Technical Service Bulletin: TSB200234	Released Date: 25-Feb-2022
New Electronic Fuel Lift Pump for Extended Life

- QST30 CM552*
- QST30 CM552 CM850*

Figure 2, Fuel Lines Connected to Fuel Filter Head Assembly.

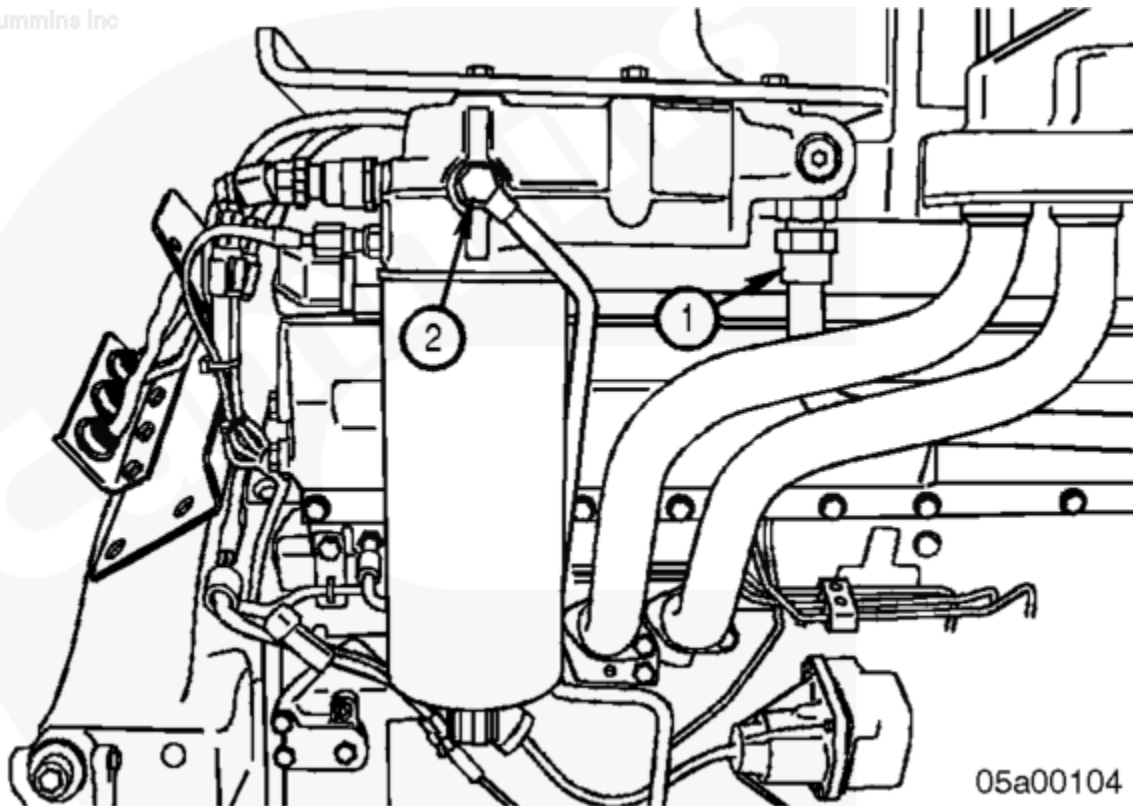
4. Connect fuel lines (Figure 2, Item 1) and (Figure 2, Item 2) to fuel filter head assembly. See corresponding Service Manual. Reference Procedure 005-045 in Section 5.

Torque Value: 40 n•m [30 ft-lb]

Figure 3, Wiring Harness Extension Connected.

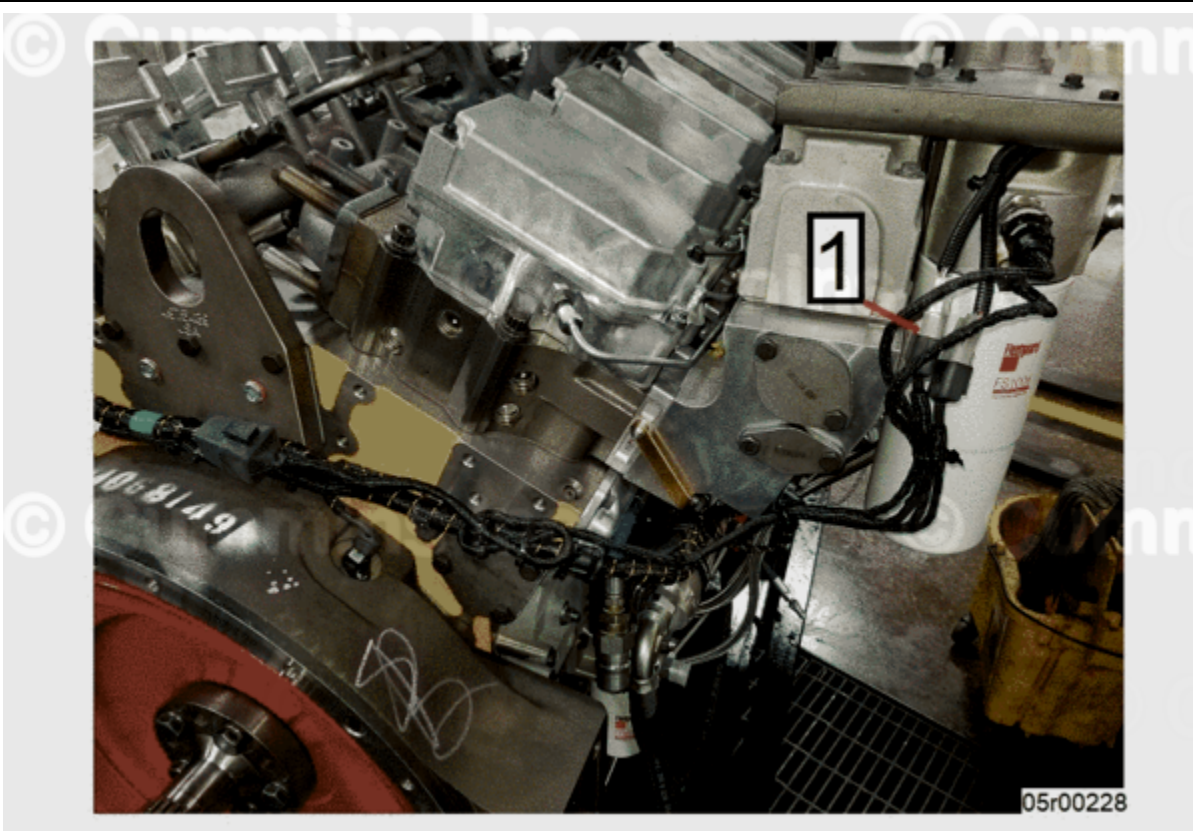
6. Add and connect wiring harness extension to relay harness pigtail connectors (Figure 3, Item 1) and fuel filter head assembly connectors.

Figure 4, Capscrew Installed in Intake Manifold Cover Plate.

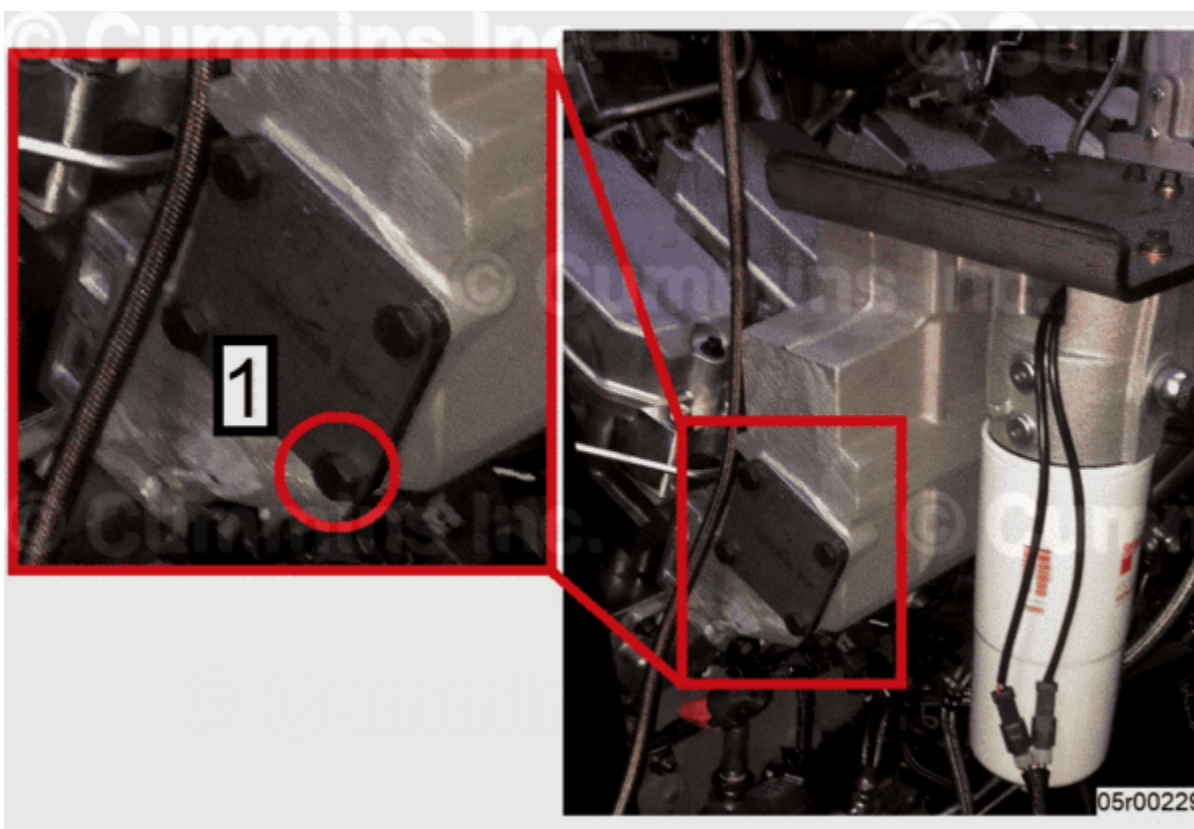
7. Hold clip and insert 5 mm [1/4 in] longer capscrew (Figure 4, Item 1) provided from kit and install in the intake manifold cover plate or return line bottom threaded hole.

Torque Value: 65 n•m [48 ft-lb]

Figure 5, Threaded Plugs and Temperature and Pressure Sensors.

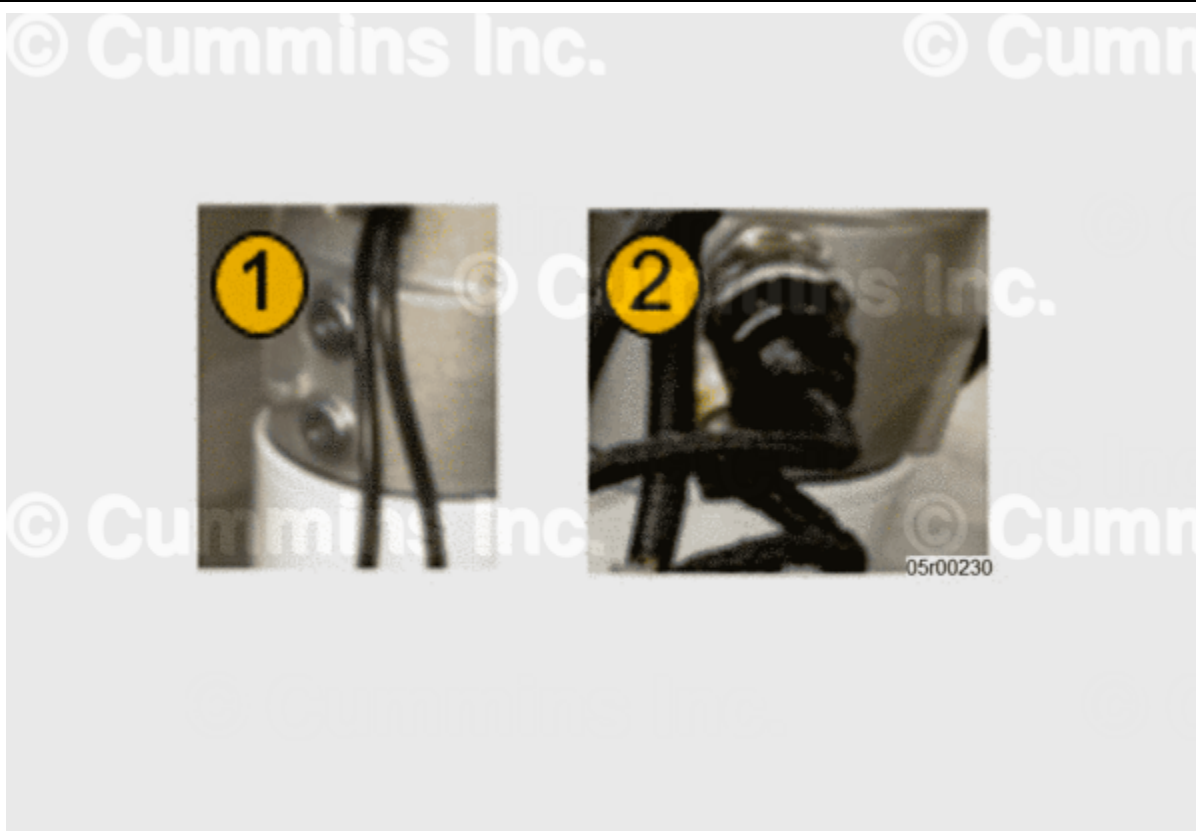
8. Install zip tie/clip to extension wiring harness and attach to intake manifold cover plate or return line flange to bottom capscrew clip installed from Step 7.
9. Install threaded plugs (Figure 5, Item 1) into fuel filter head assembly if the unit does not have temperature and pressure sensors installed from the previous setup. If temperature and pressure sensors (Figure 5, Item 2) are present, install sensor in the appropriate area.

Torque Value: 4 n•m [113 in-lb]
